Changes to proposed District Map Amendment G-956

A revised version of DMA G-956, dated June 3, 2014, has been posted on the Planning Department website for review. It contains all of the proposed and approved changes that have occurred since May 2, 2013. The following document illustrates all of the changes to DMA G-956 since April 2014.

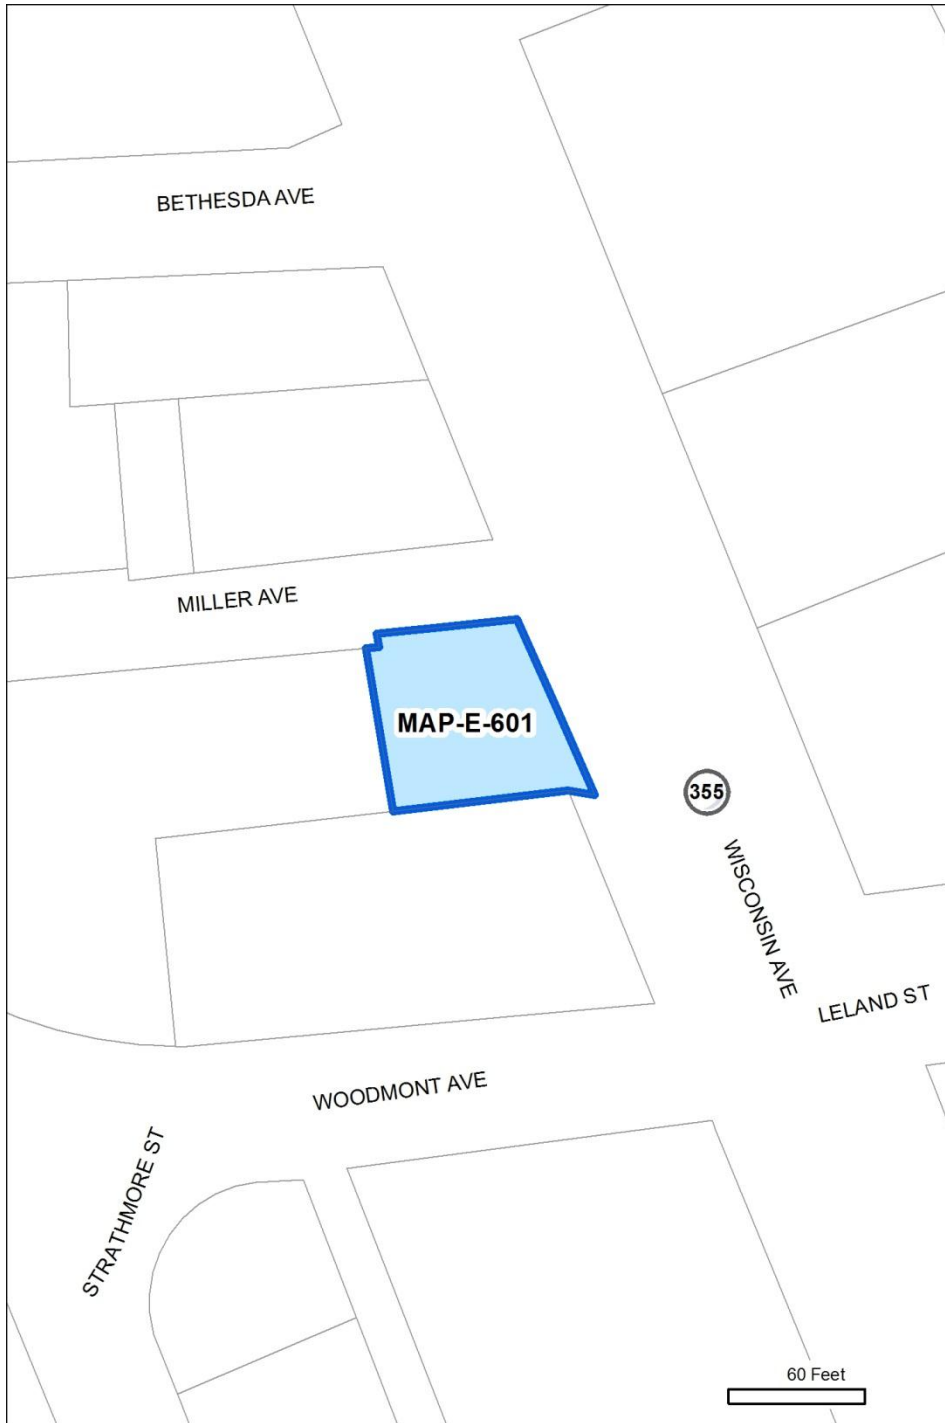
Unique ID: MAP-E-601		staff error
Master Plan ID: BTHDA-19B		
Master Plan:	Bethesda CBD	
Location:	7100 Wisconsin	
Existing Zone:	CBD-R2	
Proposed Conv: (4/18)	CR-3.0 C-1.0 R-3.0 H-75 T	
Prop. Revised Conv:	CR-3.0 C-1.0 R-3.0 H-120 T	
Category:	Error	
Modifications	Zone Group:	No change
	Overall FAR:	No change
	Comm'l FAR:	No change
	Resid'l FAR:	No change
	Height:	Increased to 120'
Reason for change:		
<p><i>This property is being developed in conjunction with the property to the south, which has been approved for development up to 120' in height by site plan 8-2013-0230.</i></p> <p><i>This part of the project, highlighted in blue, was inadvertently left out when the rest of the project was given the higher height. It is a staff error, and this property should also have been given 120' in height.</i></p> <p><i>(Note: Properties under this development were given 120' in the conversion, in accordance with the direction of the PHED Committee to map approved and existing heights and densities where they exceed those mapped in the proposed conversion.)</i></p>

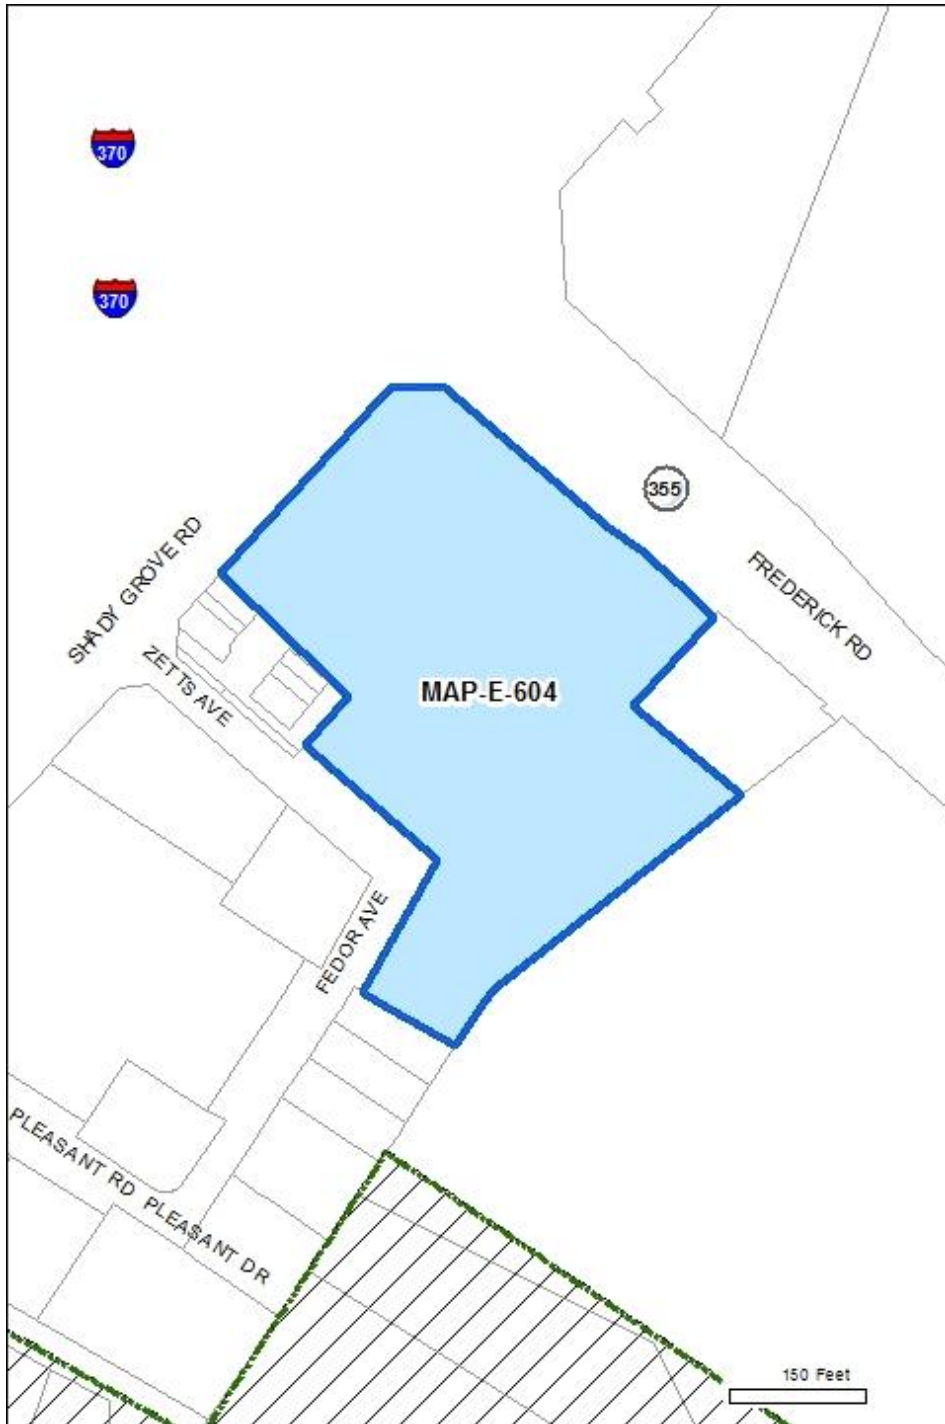
Unique ID: MAP-E-604		staff error
Master Plan ID: SDYGR-15		
Master Plan:	Shady Grove	
Location:	The Grove Shopping Center	
Existing Zone:	TS-M	
Proposed Conv: (4/18)	CR-1.5 C-1.5 R-0.25 H-80 T	
Prop. Revised Conv:	CR-0.75 C-0.75 R-0.25 H-80 T	
Category:	Error	
Modifications	Zone Group:	No change
	Overall FAR:	Reduced to 0.75
	Comm'l FAR:	Reduced to 0.75
	Resid'l FAR:	No change
	Height:	No change
Reason for change:		
<p><i>This property was rezoned to TS-M under LMA G-7. That was amended by DPA-83-4.</i></p> <p><i>Development was approved for 0.588 FAR after the DPA in 1983.</i></p> <p><i>In the April amendment to the DMA, this property's FAR was revised down to 1.5 FAR. However, staff later uncovered DPA-83-4, which gave precise square footages of approval.</i></p> <p><i>Accordingly, this site should be mapped with a maximum of 0.75 FAR (the nearest 0.25 increment to 0.588).</i></p>

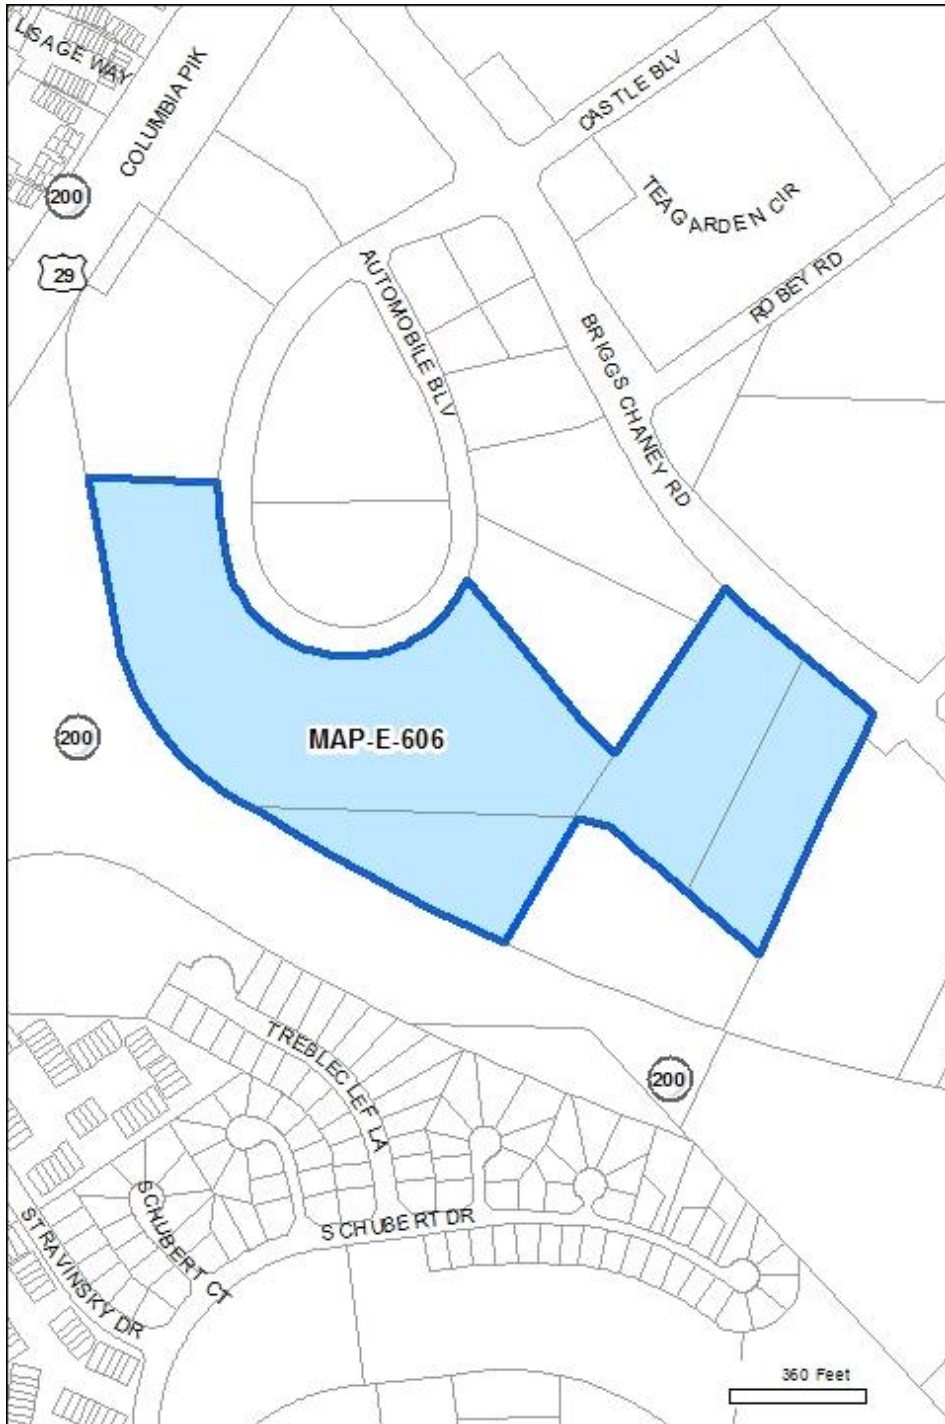
Unique ID: MAP-E-606		staff error
Master Plan ID:		
Master Plan:	Fairland	
Location:	Briggs Chaney and Automobile Bl	
Existing Zone:	C-3	
Proposed Conv: (4/18)	GR-1.5 H-45	
Prop. Revised Conv:	GR-1.5 H-85	
Category:	Error	
Modifications	Zone Group:	No change
	Overall FAR:	No change
	Comm'l FAR:	-
	Resid'l FAR:	-
	Height:	Increased to 85'
Reason for change:		
<p><i>This site is part of the Auto Sales Park off of Briggs Chaney Road. Under §59-C-4.361 of the existing Montgomery County Zoning Ordinance, building height in the C-3 zone is permitted to go up to 84' for an auto sales and service mall.</i></p> <p><i>This site is part of the auto sales and service mall, and should have been granted the higher height.</i></p> <p><i>Staff erroneously limited height here to the standard height for all other uses in the C-3 zone.</i></p>

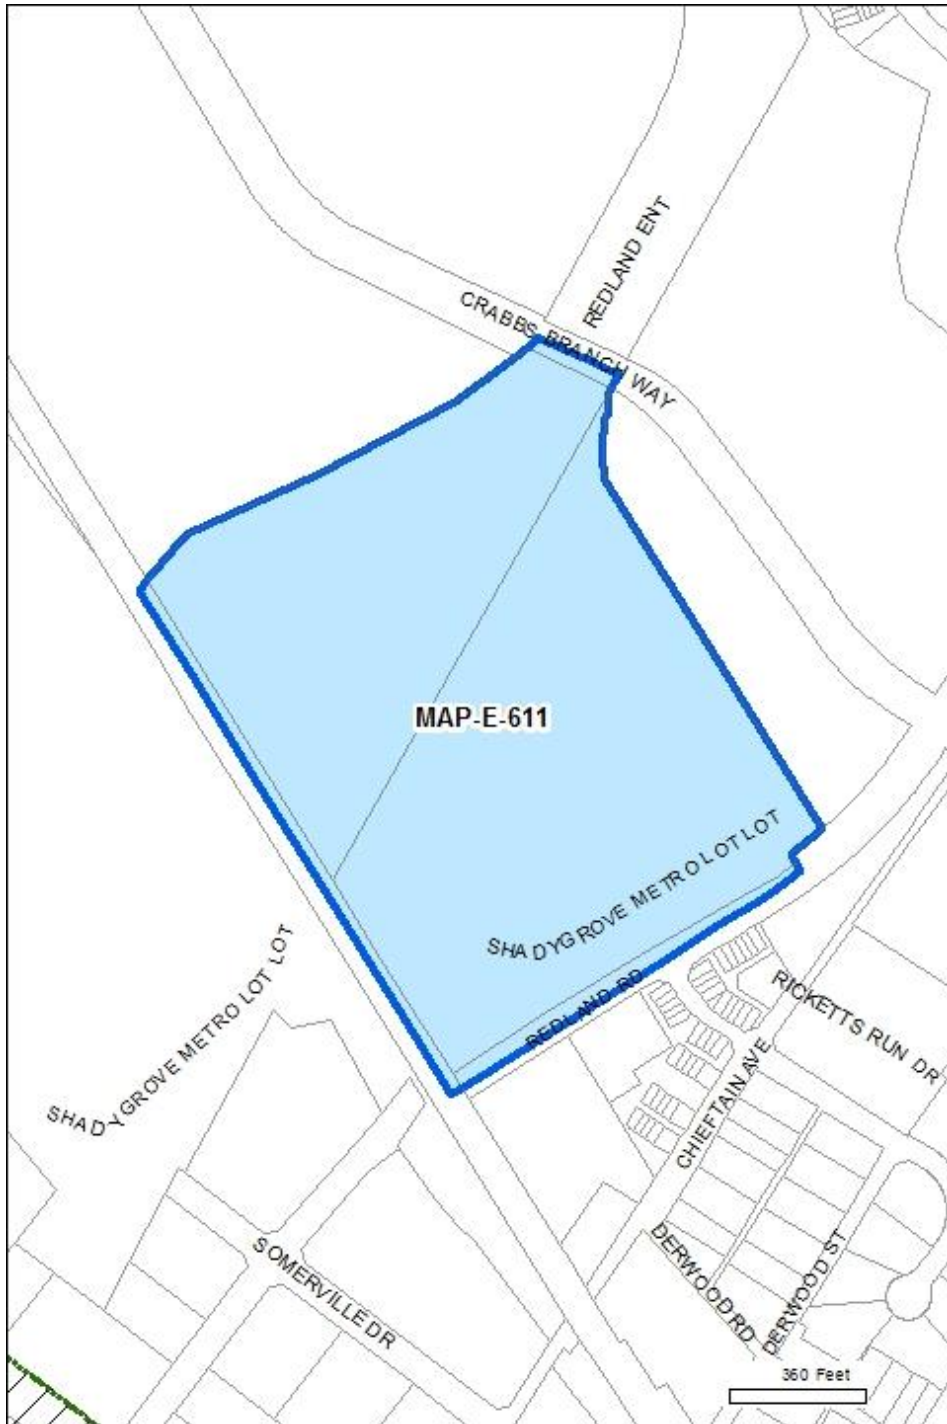
Unique ID: MAP-E-611		staff error
Master Plan ID: SDYGR-07		
Master Plan:	Shady Grove	
Location:	Shady Grove Metro Station	
Existing Zone:	TOMX-2/TDR	
Proposed Conv: (4/18)	TDR-0.89	
Prop. Revised Conv:	TDR-0.88	
Category:	Error	
Modifications	Zone Group:	-
	Overall FAR:	-
	Comm'l FAR:	-
	Resid'l FAR:	-
	Height:	-
Reason for change:		
<p><i>This site is currently zoned TOMX-2/TDR. As part of the rewrite, this site will have a TDR overlay atop it (and the base zone will be rezoned to CRT).</i></p> <p><i>In the April round of changes staff adjusted the base zoning, which resulted in a change to the TDR overlay.</i></p> <p><i>The change should have remapped the TDR overlay on this site to TDR-0.88, however it was inadvertently mapped to TDR-0.89 in error.</i></p> <p><i>This change will correct the TDR designation here to the correct TDR-0.88.</i></p>

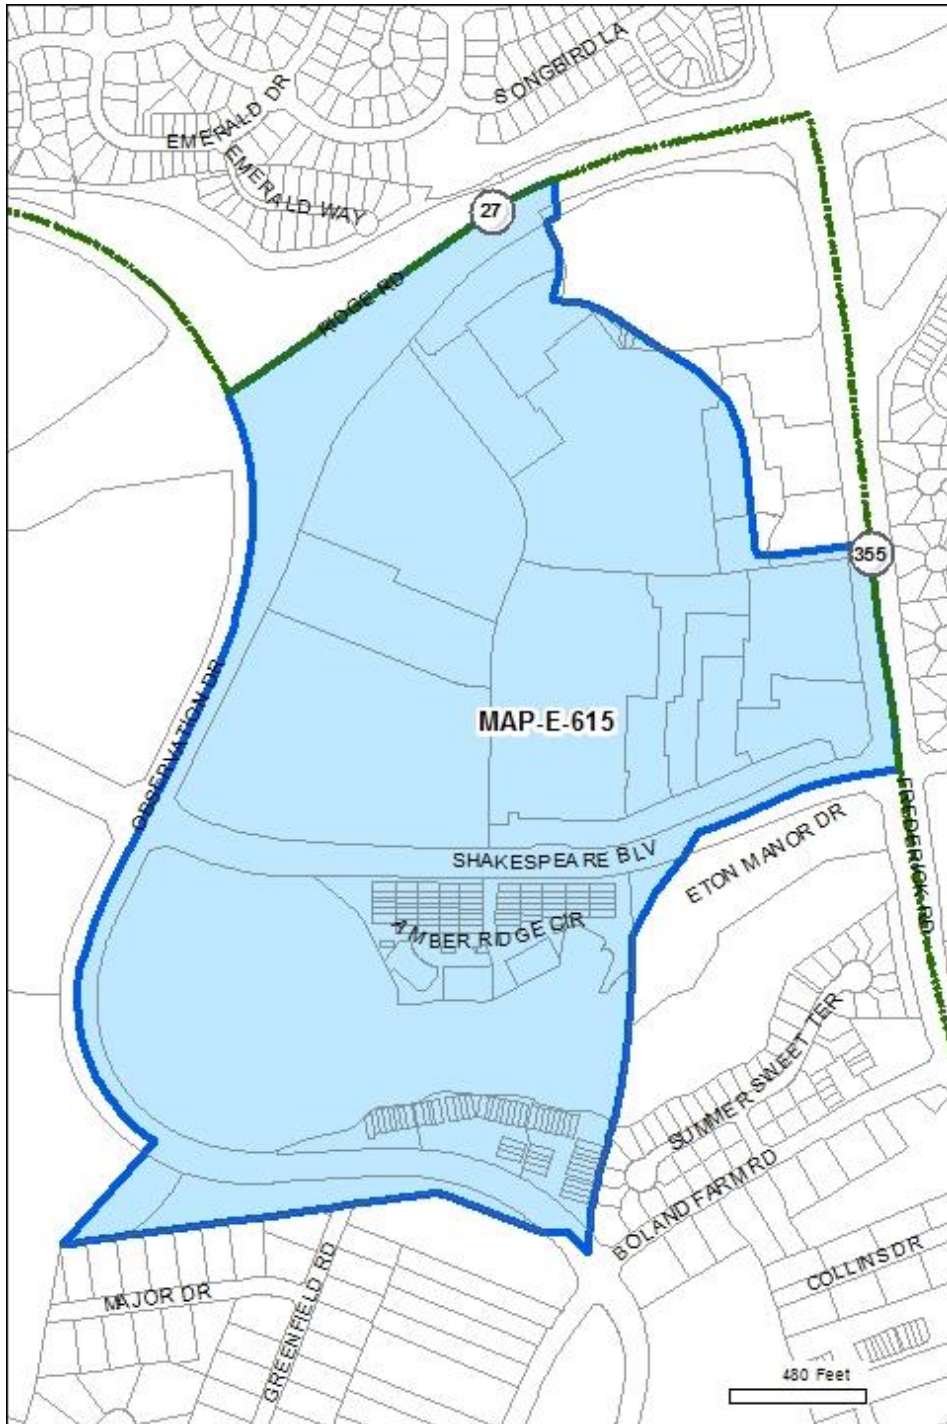
Unique ID: MAP-E-615		staff error
Master Plan ID:		
Master Plan:	Germantown Town Center	
Location:	Milestone Center	
Existing Zone:	RMX-3/TDR	
Proposed Conv: (4/18)	TDR-1.34	
Prop. Revised Conv:	TDR-1.29	
Category:	Error	
Modifications	Zone Group:	-
	Overall FAR:	-
	Comm'l FAR:	-
	Resid'l FAR:	-
	Height:	-
Reason for change:		
<p><i>This site is currently zoned RMX-3/TDR. As part of the rewrite, this site will have a TDR overlay atop it (and the base zone will be rezoned to CRT).</i></p> <p><i>The TDR overlay on this site should be TDR-1.29, however it was inadvertently mapped to TDR-1.34 in error.</i></p> <p><i>This change will correct the TDR designation here to the correct TDR-1.29.</i></p>

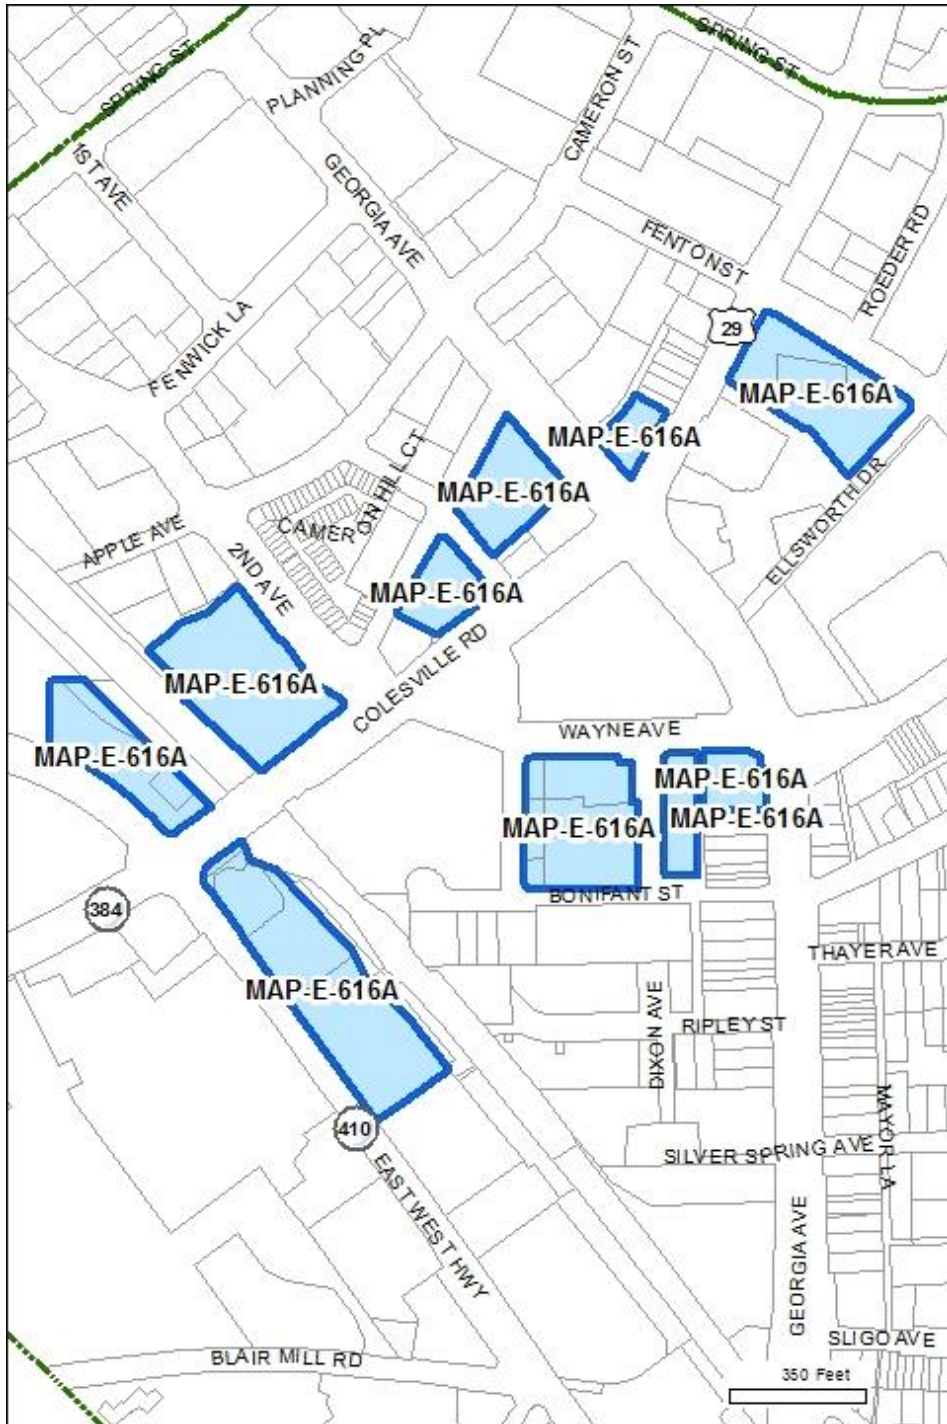
Unique ID: MAP-E-616A		staff error
Master Plan ID:		
Master Plan:		Silver Spring CBD
Location:		
Existing Zone:		CBD-3
Proposed Conv: (4/18)		CR-8.0 C-6.0 R-6.0 H-200 T
Prop. Revised Conv:		CR-8.0 C-6.0 R-7.5 H-200 T
Category:		Error
Modifications	Zone Group:	No change
	Overall FAR:	No change
	Comm'l FAR:	No change
	Resid'l FAR:	Increased to 7.5
	Height:	No change
Reason for change:		
<p><i>In earlier versions of the DMA, CBD-3 was converted with 7.5 FAR of residential development. The current ordinance limits solely residential projects to 200 dwelling units per acre, however, it does not put a limit on residential density in mixed-use projects.</i></p> <p><i>After internal discussion, staff felt that the 200 dwelling units per acre limitation was a more appropriate limit, since under the CR zone it was not possible to differentiate between single-use and mixed-use projects. Therefore, staff changed the proposal to reflect a residential limit of 6.0 FAR.</i></p> <p><i>However, upon further discussion, and with input from others familiar with the zone, staff determined that reducing the FAR to 6.0 would be a significant reduction in what could actually be built, since today a project could be developed with very minimal commercial FAR and still be allowed to build almost 8.0 FAR of residential.</i></p> <p><i>Therefore, staff believes the earlier change (MAP-E-590) was in error, and is returning the CBD-3 conversion to its original CR-8.0 C-6.0 R-7.5 H-200T.</i></p>
